Determination 2019/061

Regarding the compliance of a surface water drainage connection at 37A Miles Lane, Tauriko, Tauranga

Figure 2: The consented surface water disposal system

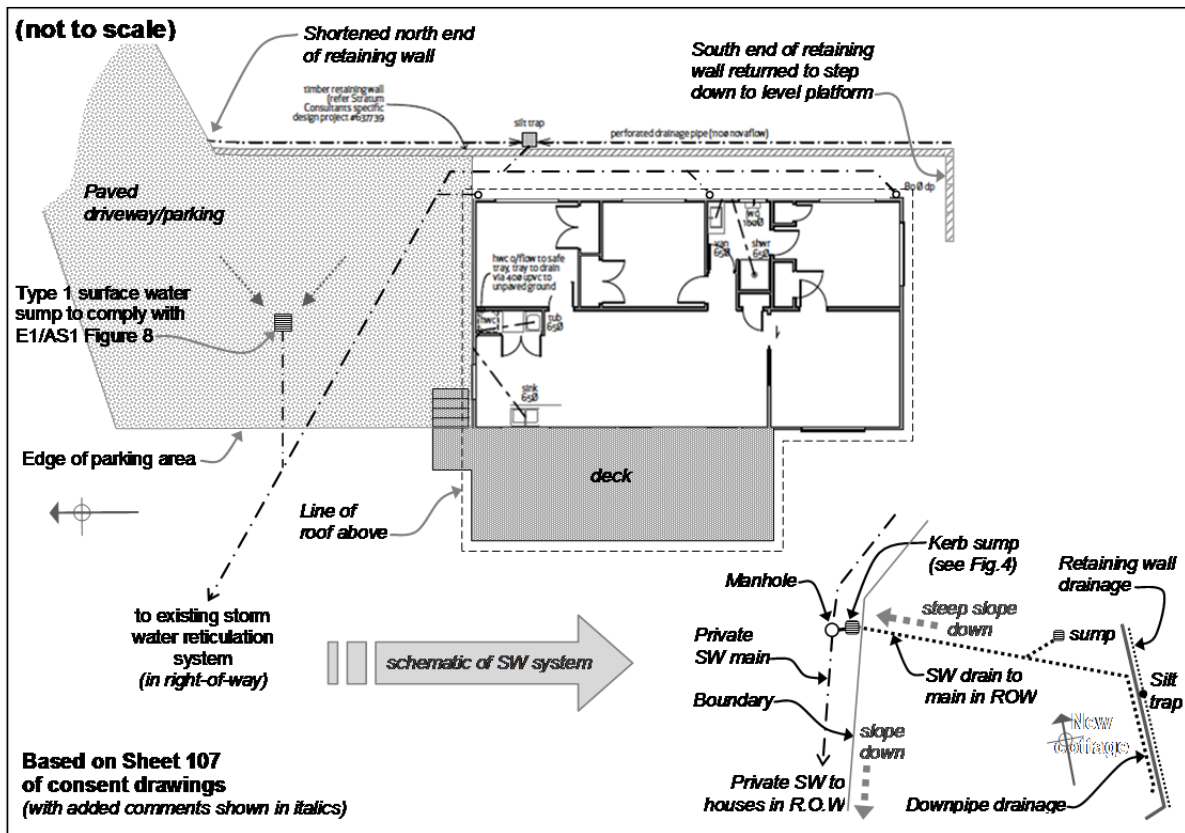
- 2.3.2 Perforated pipe installed behind the east timber retaining wall drains to a silt trap, which is connected into the underground surface water drain as shown in Figure 2:

- 2.3.5 The drain was connected into the existing private road kerb sump adjacent to the manhole as shown in the schematic in Figure 2 to avoid damaging the recently resealed road surface. However, I note that an earlier connection application form had ticked a connection to the manhole not the kerb sump.

1. STORM WATER CONNECTION IS NOT AS PER PLAN, IT IS CONNECTED TO A TYPE TWO SUMP IN THE NEIGHBOURS PROPERTY⁴, THIS DOES NOT SHOW COMPLIANCE TO E1.

Figure 3: Connection to the kerb sump in the private road (not to scale)

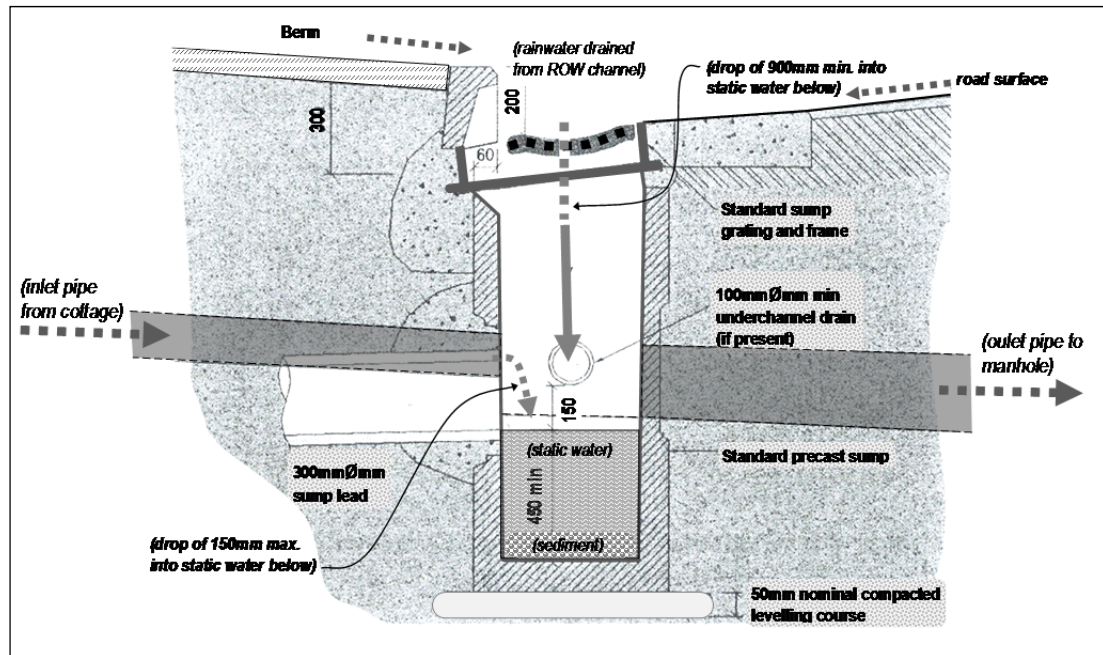
- Figure 3 shows the approximate position of the property's inlet surface water pipe in relation to the tapped water level within the sump
- although authority staff noted concerns that discharging roof water into the kerb sump could stir up sediment in the sump:
 - there is far more risk of that occurring from kerb collected rainwater falling through the significantly higher surface-mounted sump grate
 - the pipe from the property aligns with the top of the outlet pipe – so is close to the trapped water level; reducing the risk of sediment being stirred up from the property's discharge
- discharging into a kerb sump also allows further silt to be removed from the property's drain prior to it entering the private surface water system.

4.3.4 There would appear to be no reason why a surface water drain from a roof cannot also enter the sump so long as the sump’s performance in collecting silt and debris is not compromised and the following is noted with respect to the as-built kerb sump connection shown in Figure 3:

- The water level in the kerb sump is at the invert of the outlet pipe, which provides a trapped water depth of approximately 450mm for silt and sediment

to collect and settle. (A type 2 sump described in E1/AS1 shows a minimum trapped water depth of 380mm.)

- The property's surface water drain collects water from an area of 380m² (according to the services report). The 100mm diameter pipe from the property's surface water drain enters the sump at a maximum of 150mm above the trapped water level, providing a limited height from which the surface water from the property will drop into the sump and disturb the collected sediment.
- The service road has a gradient of approximately 1:8 running towards the kerb sump, and the sump collects water from approximately 250m² of paved road. The kerb channel discharges through the grate into the sump, with a fall in excess of 900mm into the trapped water.

4.3.5 In my view the effect of the surface water coming from the service road is more likely to have a detrimental effect on the kerb sump's ability to collect silt and sediment than the surface water pipe from the property which I consider will have a negligible effect on the performance of the sump. I note that if the surface water pipe from the property had entered the sump at a point where collected sediment would have been disturbed then, in my view, the sump's performance could have been compromised.

4.3.7 Taking account of the above I consider the property's surface water pipe draining to the outfall at the kerb sump as described above will comply with Clause E1.3.1(a).

- 5.1 In accordance with section 188 of the Building Act 2004, I hereby determine that the kerb sump connection complies with Building Code Clause E1 Surface water.
